Product Change Notification

PCN-ICC-1619-2018

Business Unit	Product Line Code	Type of Change	Action	Date of Issue
ICC - Industrial Cabinet	BE6	Product Change Notification	Notify Distributors and Field	5/15/2018

Description for Product Change Notification

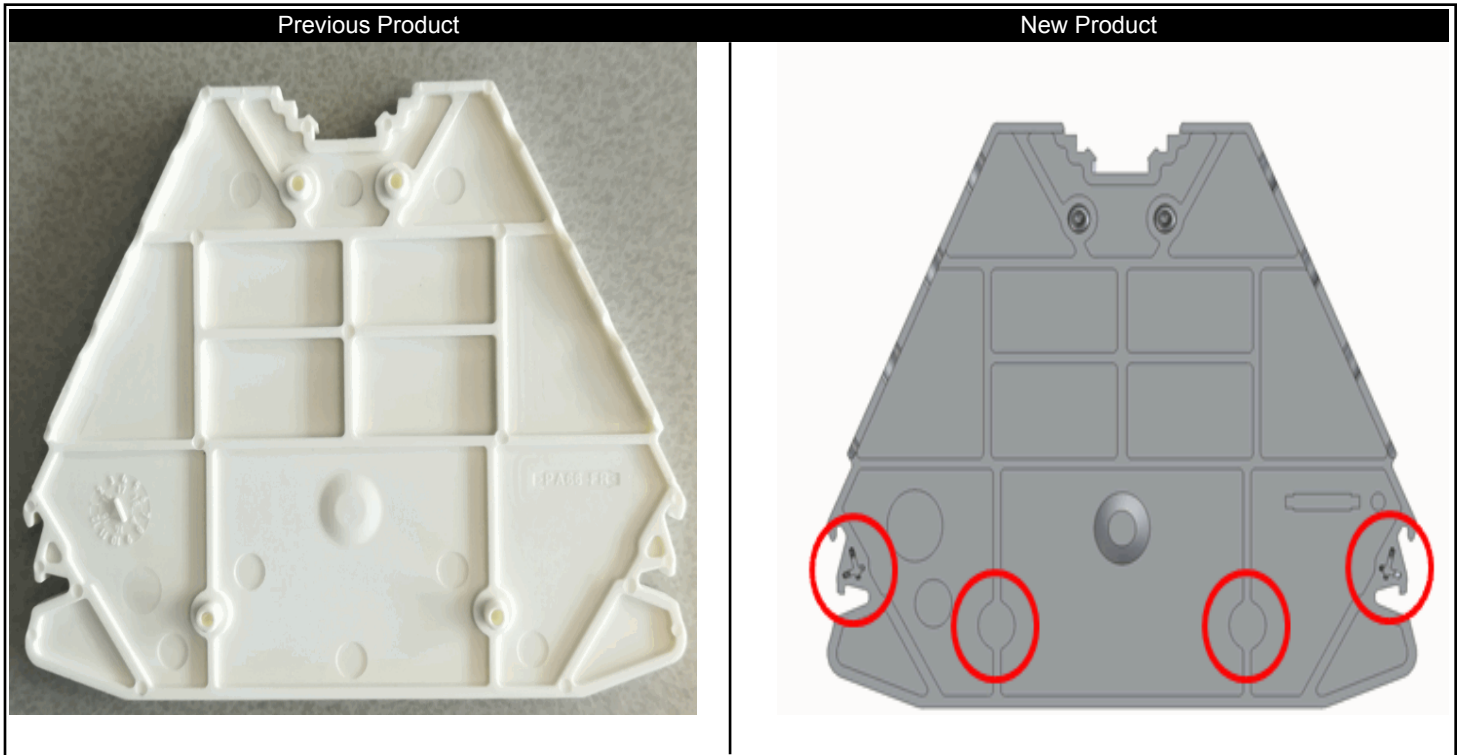
D-PTRV 4 has been modified to fit the new and upcoming PTRVB-4-PE terminal. Pins in the middle have been removed and pins on the side have been added.
